## ADDENDUM NO. 1

Board of Education – New Parking Lot

San Bernardino City Unified School District

RCA Project No. 1-78-60

C-4.0

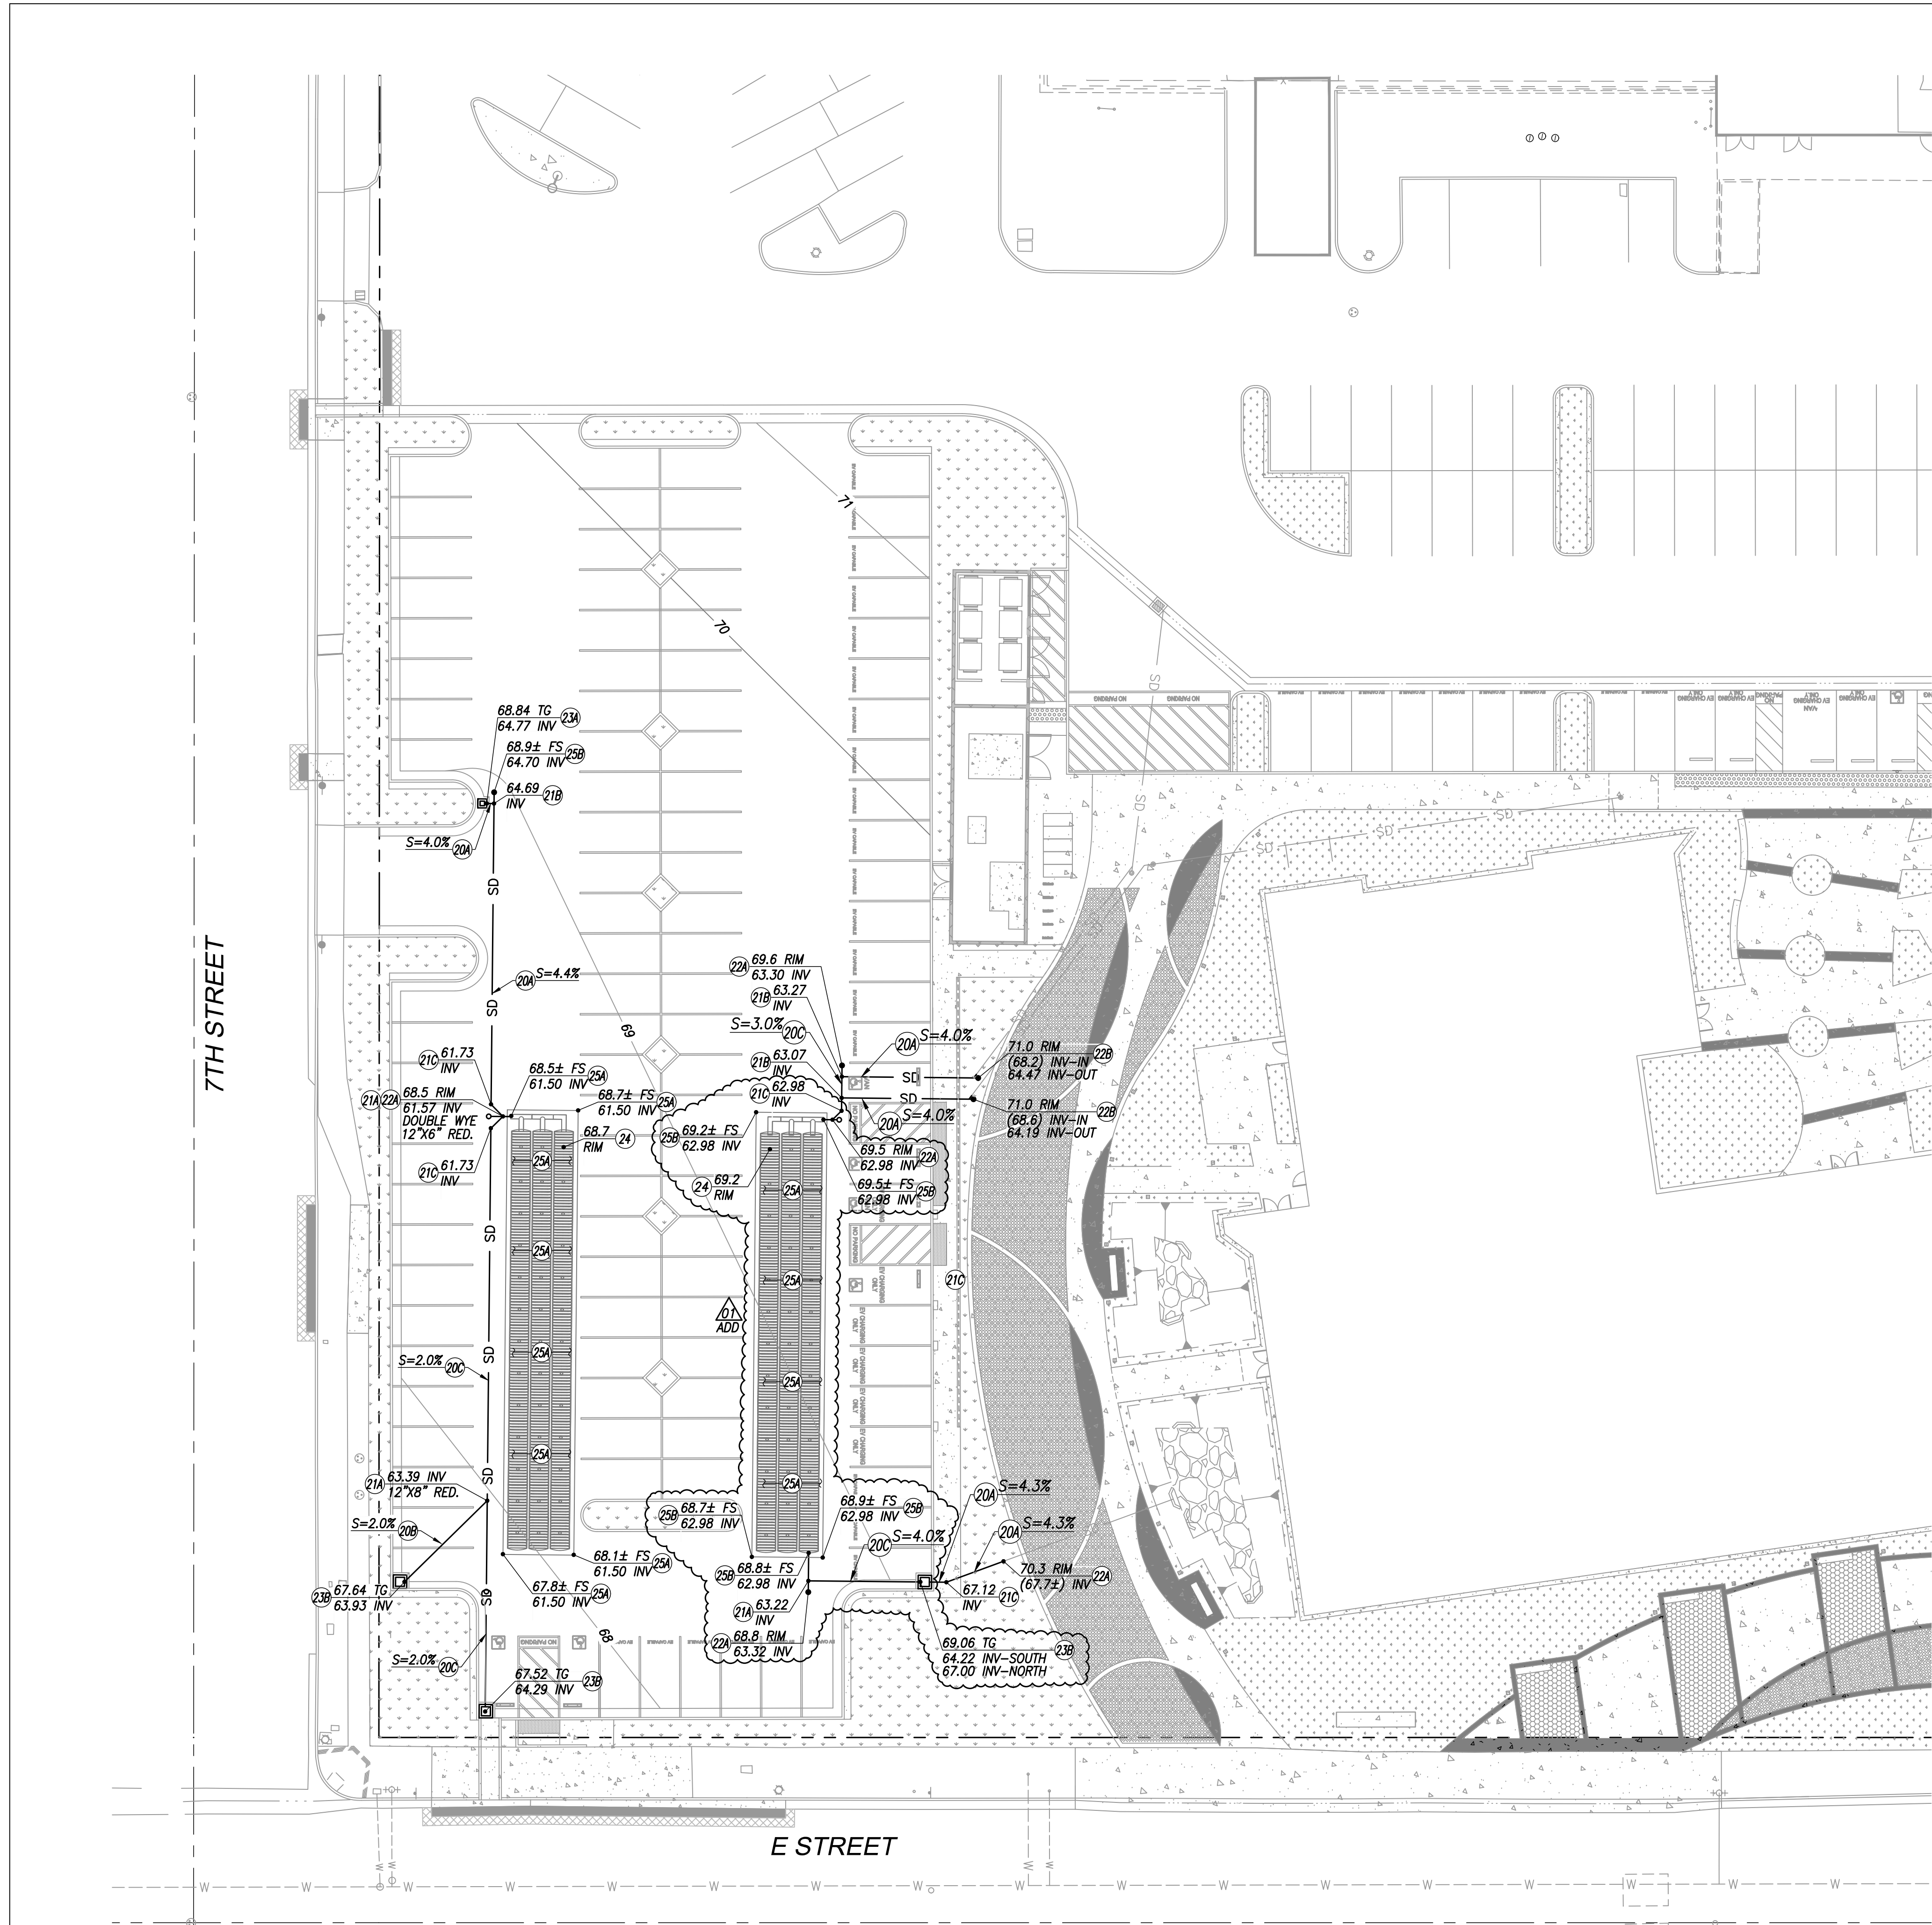
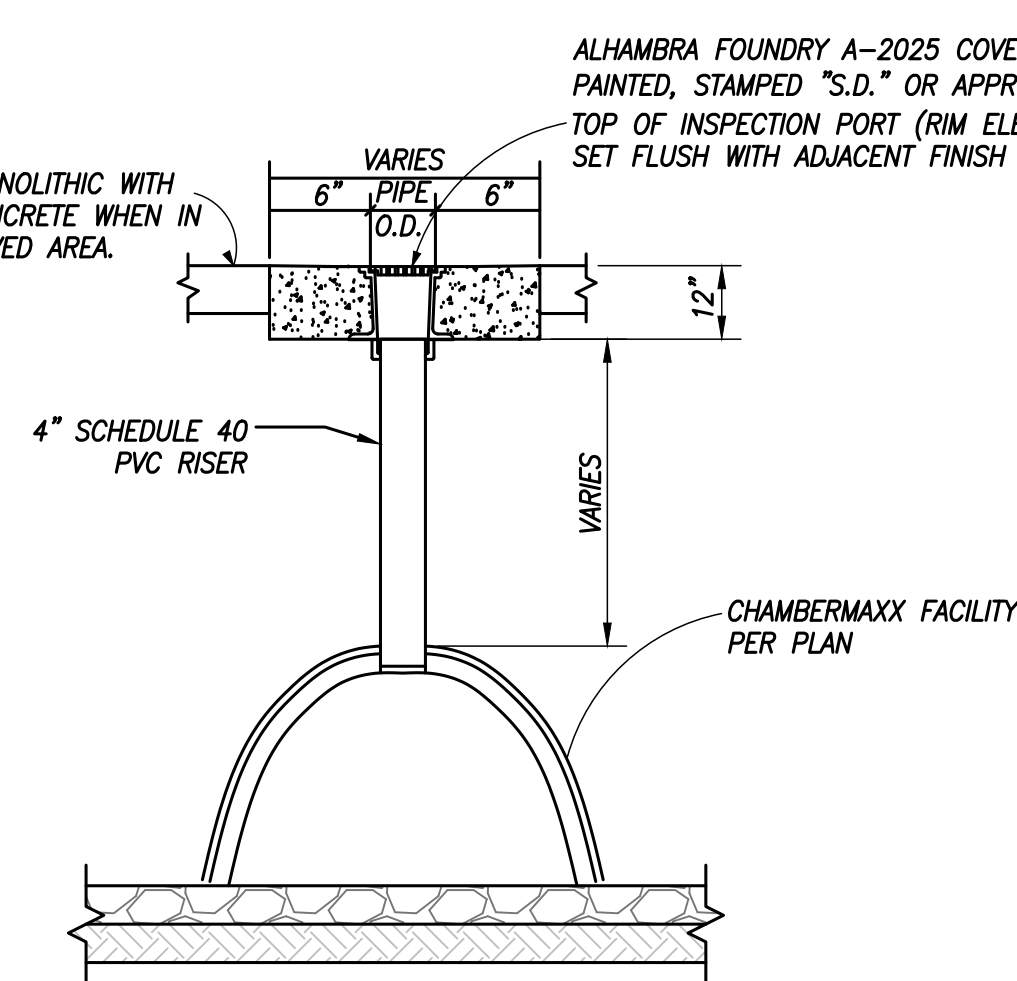
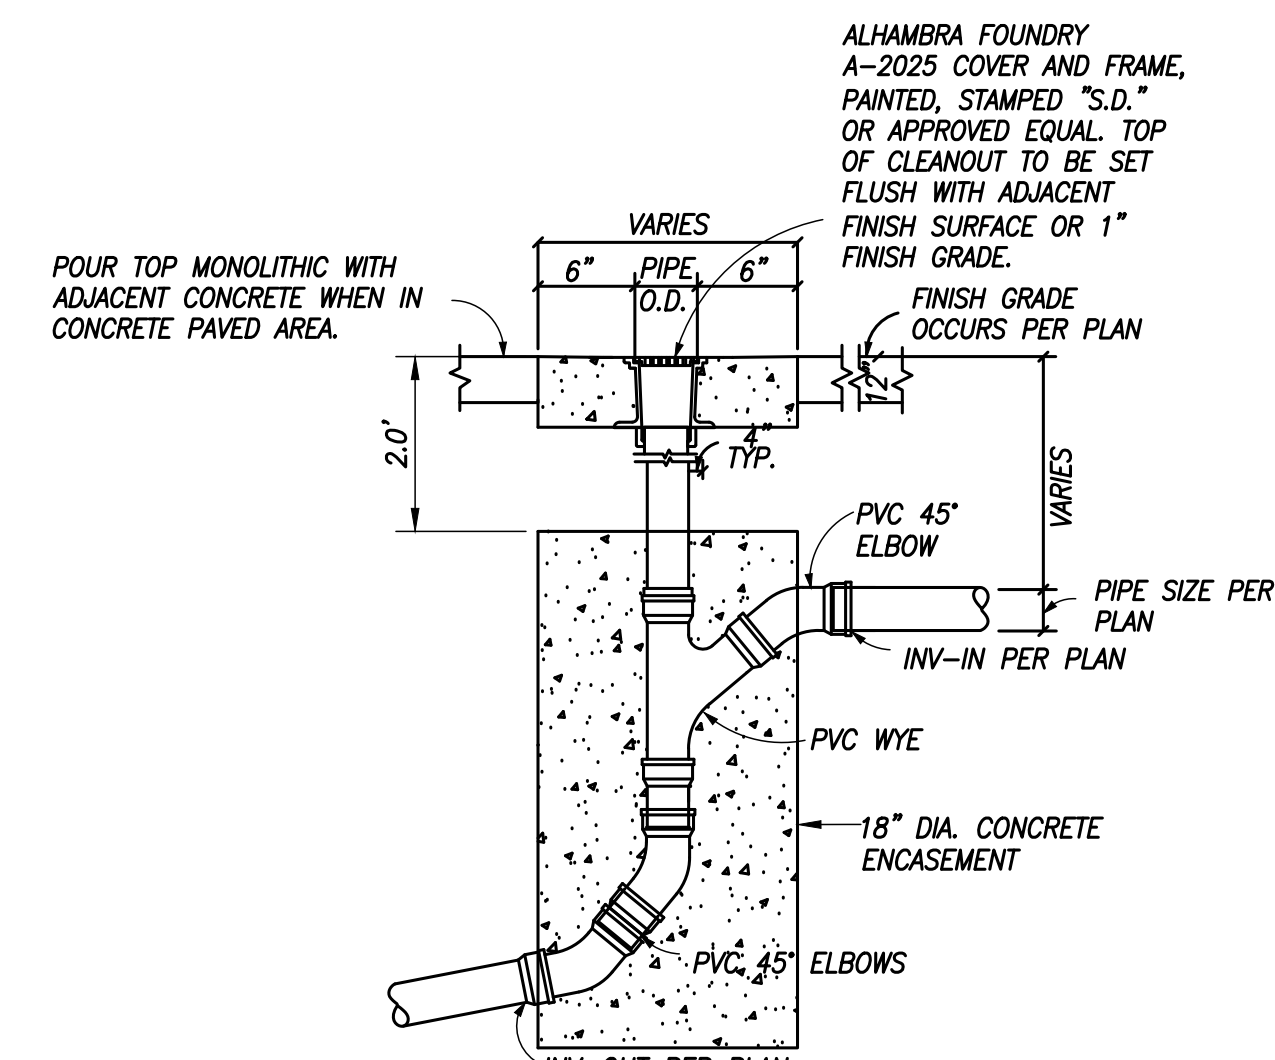
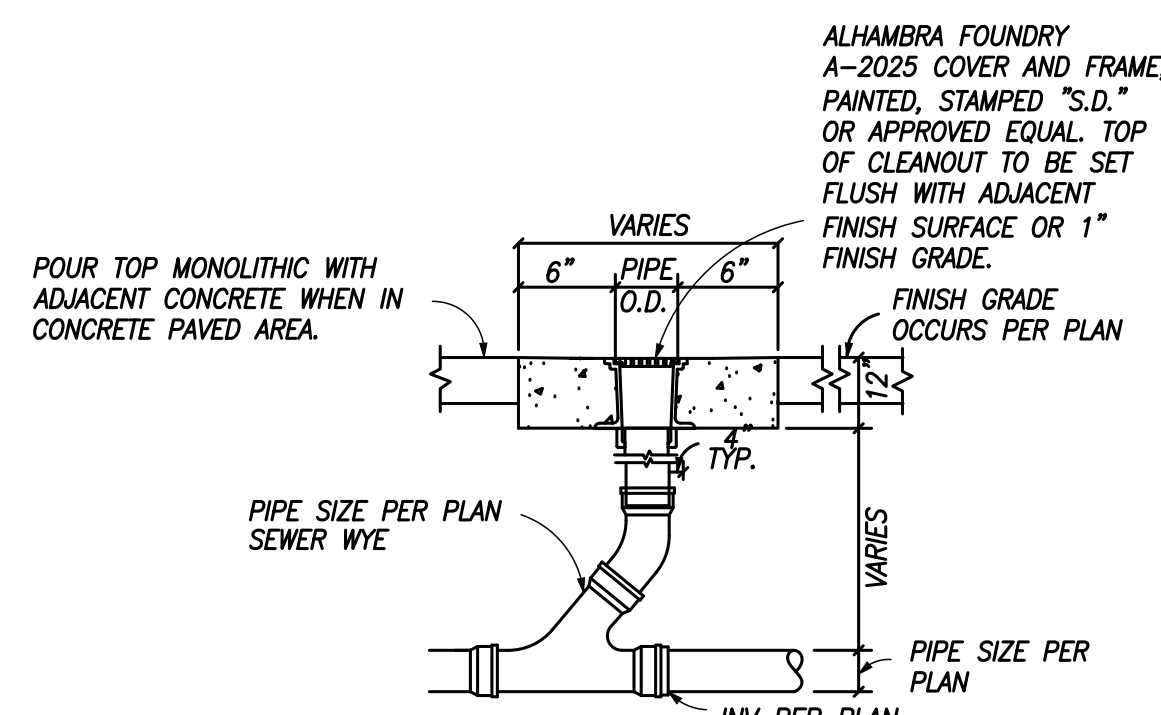
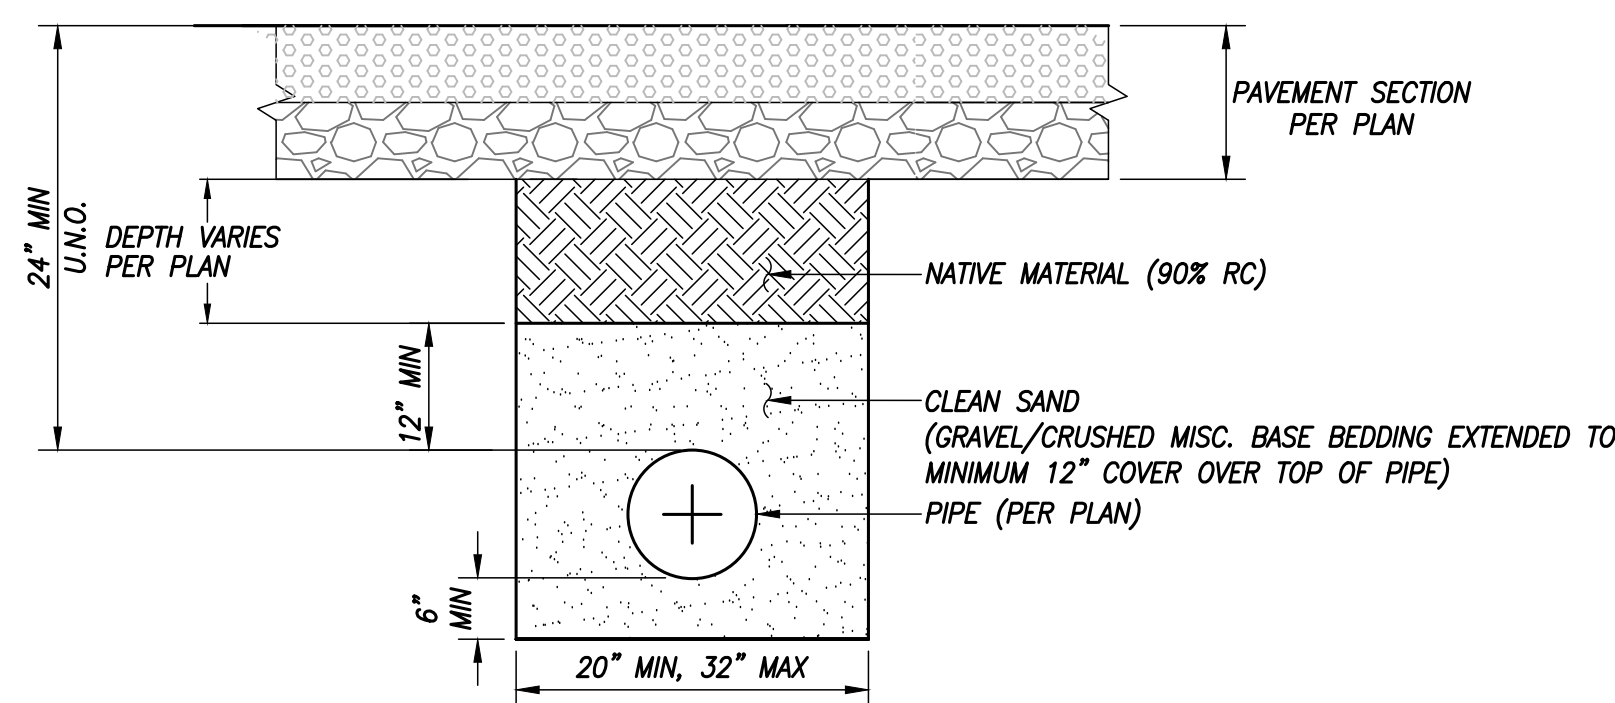
- Item No. 1.6      Reference Sheet C-4.0 – STORM DRAIN PLAN  
1.6.1      Replace Sheet C-4.0 and revise per clouded areas listed below:

- (a) Revised size of retention basin.
- (b) Removed note from storm drain notes list.
